Staff Memorandum

Historic Preservation Board

DATE: May 8, 2018

SUBJECT: HPB17-0142, **1600 Washington Avenue, 425 16th Street & 1601 Drexel Avenue.**

425 16th Street, microfilm elevations

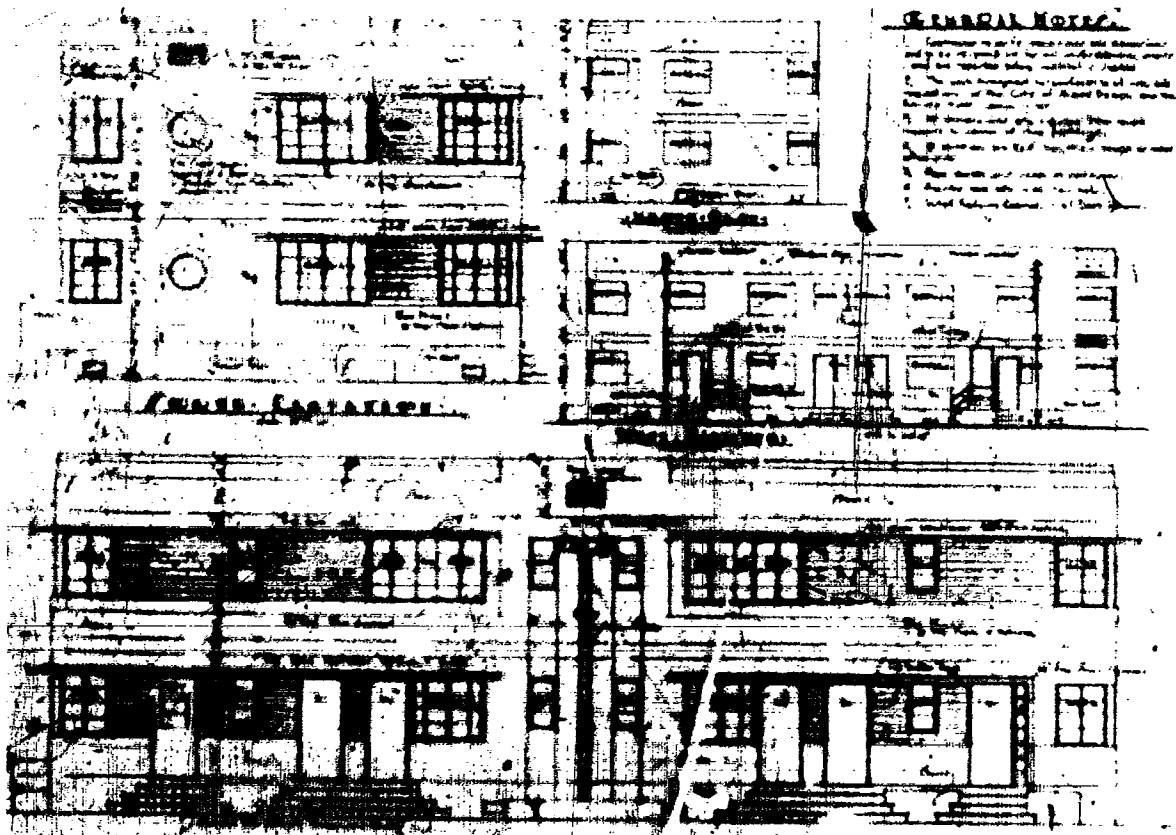
- a. Exterior architectural features.
Not Satisfied
The window design proposed for the restored and reconstructed portions of the Contributing building is not consistent with the original design.

The window design proposed for the restored and reconstructed portions of the Contributing building is not consistent with the original design.

While this structure is no longer a part of a cohesive grouping of buildings, it retains a high degree of historic and architectural integrity, with only limited modifications. Staff commends the applicant for proposing to partially retain and restore this Contributing building as part of the currently proposed redevelopment project. Staff has only one concern with regard to the restoration details presented. Specifically, staff would strongly recommend that all windows within the retained and reconstructed portions of the building be removed and replaced with casement windows including an applied muntin pattern that is as consistent as possible to the original design, as shown in the image below.

- i. The existing windows shall be removed; new casement windows shall be provided and shall incorporate a muntin configuration that is consistent with the with the original design, in a manner to be reviewed and approved by staff consistent with the Certificate of Appropriateness Criteria and/or the directions from the Board.
